UNITED STATES PATENT AND TRADEMARK OFFICE

APPLICATION NO.	FILING DATE	FIRST NAMED INVENTOR	ATTORNEY DOCKET NO.	CONFIRMATION NO.
10/524,523	02/11/2005	Peter Tiemann	2002p00241WOUS	1108

Office Action Summary	Application No. 10/524,523	Applicant(s) TIEMANN ET AL.	
	Examiner GERALD L. SUNG	Art Unit 4156

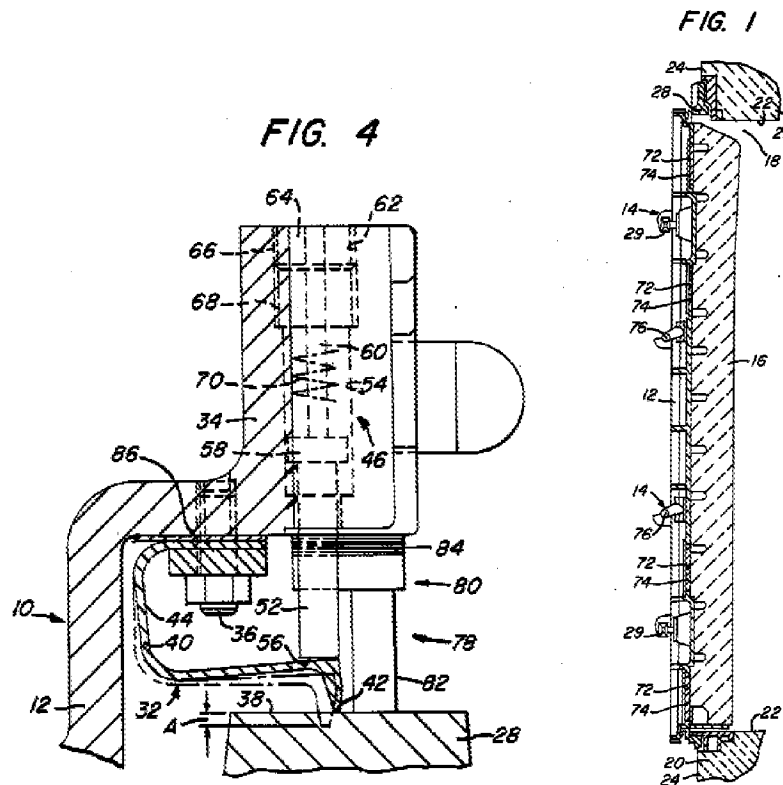
2. Regarding claim 8, Babcock et al. disclose improvements to a combustion chamber where the installations include an access means to access the interior of the combustion chamber. Babcock et al. disclose that "[i]n such installations the enclosing walls are often fluid cooled to provide protection from high furnace temperatures and further are preferably made gas tight throughout to avoid the troublesome and dangerous condition resulting from the ejection of high temperature gases and other products of combustion" (page 1, lines 27-35). DuBell et al. are relied upon to teach well known methods in the art where cooling air is passed in between an inner liner 50 and a wall 48. Furthermore, Babcock et al. teach the motivation to include a wall opening in a combustion chamber for the purposes of accessing the interior of the combustion chamber for maintenance purposes. With regards to the wall opening, Babcock et al. disclose "[w]hen a wall opening is provided through which access may be had to the interior for cleaning or other purposes it is essential that the opening be fitted with closure means suitably constructed and arranged so as to maintain the continuity of the gas-tight wall construction" (page 1, lines 35-42). Albrecht et al. disclose a water

jacketed high-temperature stretcher accessible door for a boiler which includes inner cooling chambers. One of ordinary skill in the art at the time of the invention would have found it obvious to modify the combustion chamber in Babcock et al. with well known methods of combustion chamber wall cooling such as those taught by DuBell et al. in order to provide an efficient cooling means to cool the combustion chamber and a cooled door such as the door taught by Albrecht et al. in order to provide a means to access the interior of the combustion chamber for maintenance purposes. Furthermore, since Babcock et al. disclose a "closure means... wherein at least one port is provided for the admission of cooling gaseous fluid to the passage through the door frame member when the door is closed," (page 6, lines 20-25) one of ordinary skill in the art, in light of the well known combustion chamber cooling means taught by DuBell et al., would have found it obvious to combine the elements in Babcock et al. and Albrecht et al. in order to provide a more efficient cooling means where the continuity of the cooling chambers in the combustion chamber and the door would have yielded a more cost effective and efficient system by reducing the number of cooling systems required by the combustion chamber. Therefore, it would have been obvious to one of ordinary skill in the art at the time of the invention to modify the combustion chamber disclosed by Babcock et al. with a cooling chamber 46 taught by DuBell et al. and an access door taught by Albrecht et al.
